DISPOSITION OF PUBLIC COMMENTS

Technical Criteria for Approving Side-Facing Seats, Policy No. PS-ANM-25-03-R1

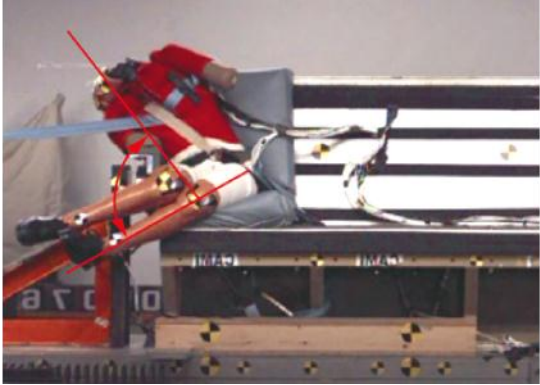
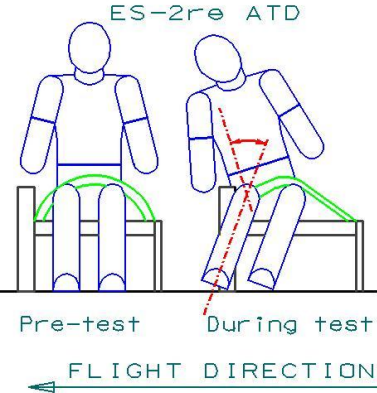
No.	Comment	Requested Change	Disposition
			<p>provided by the previous requirement for full-body support.</p> <p>When an occupant is seated next to an end closure, lower-leg flail can be readily determined from video as documented in DOT/FAA/AM-07/13. We agree with the commenter that determining the rotation angle is easier to accomplish when the ATD is seated next to an end closure that holds the legs in a direction normal to the inertial load. In FAA tests, that seat configuration was the only one to produce excessive axial rotation. Additional video-camera angles may be necessary to evaluate the criteria if a seat configuration produces excessive rotation while the femurs are not normal to the inertial load.</p>
	Commenter: ANAC		
1	Attachment 1, Special Condition 2(e): how to evaluate, in practical means, the leg flailing angle? Normally for this kind of installation, it is possible for the ATD body to rotate as a whole, making this evaluation difficult (see bottom picture):		<p>The injuries sustained in the PMHS tests are not ambiguous in origin (the spiral fracture in one subject and the distal-shaft fracture in the other subject are indicative of torsion loading). The injury is repeatable and would be expected in any impact that produces significant torsion loading of the femur. The test results show that sufficient torsion to cause serious injury can be caused by inertial forces acting on an unsupported lower leg. The only way to prevent an injury caused by rotation of a joint beyond its natural limit is to prevent that rotation. Additional research could further define the relationship between rotation angle and injury probability, and help in developing more-sophisticated methods of determining the</p>

No.	Comment	Requested Change	Disposition
	 <p data-bbox="201 678 737 764">In this case, it is simple to evaluate the leg flailing angle: the upper leg is kept relatively in place while the lower legs rotate</p>  <p data-bbox="201 1219 533 1240">Schematics of above picture</p>		<p data-bbox="1325 282 1990 456">rotation during tests. However, at this time, limiting rotation to a value unlikely to cause injury is the only means of providing the level of safety provided by the previous requirement for full-body support.</p> <p data-bbox="1325 480 1990 943">When an occupant is seated next to an end closure, lower-leg flail can be readily determined from video as documented in DOT/FAA/AM-07/13. We agree with the commenter that determining the rotation angle is easier to accomplish when the ATD is seated next to an end closure that holds the legs in a direction normal to the inertial load. In FAA tests, that seat configuration was the only one to produce excessive axial rotation. Additional video-camera angles may be necessary to evaluate the criteria if a seat configuration produces excessive rotation while the femurs are not normal to the inertial load.</p>

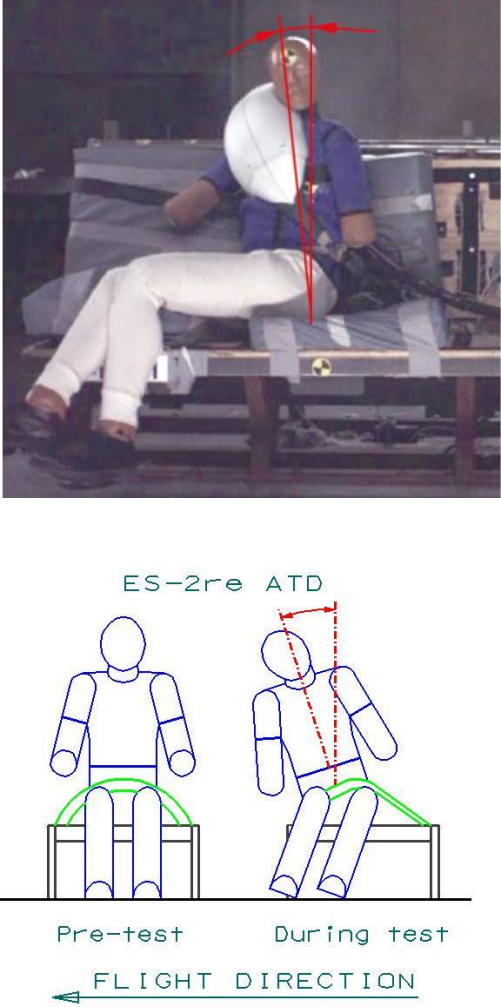
No.	Comment	Requested Change	Disposition
	 <p>How to evaluate the leg flailing angle in this case?</p>		
2	Attachment 1, Special Condition 2(h)(3): for evaluation of lateral flexion of ATD torso, is it correct to perform an photometric evaluation of the test shooting (for example, according to the picture below)?		Additional camera views may be necessary to discern whether the torso flexion is forward or lateral.
